Product / Process Change Notification (PCN)

PCN #: PCN_WL-SBCC_20190524

Affected Series: WL-SBCC; 150060RV75240

Before:

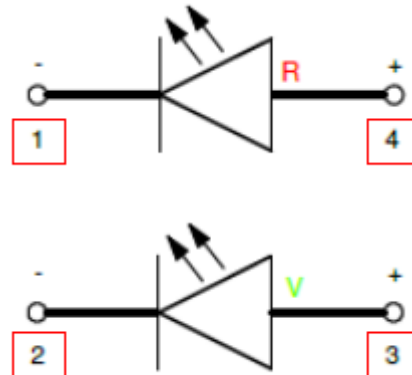
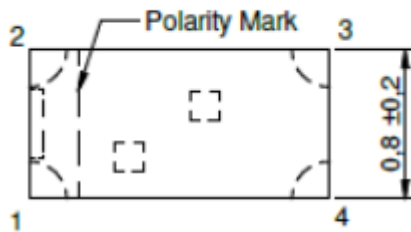
Because of a database mismatch, Würth Elektronik corrected the drawing of schematic. The component itself didn't change.
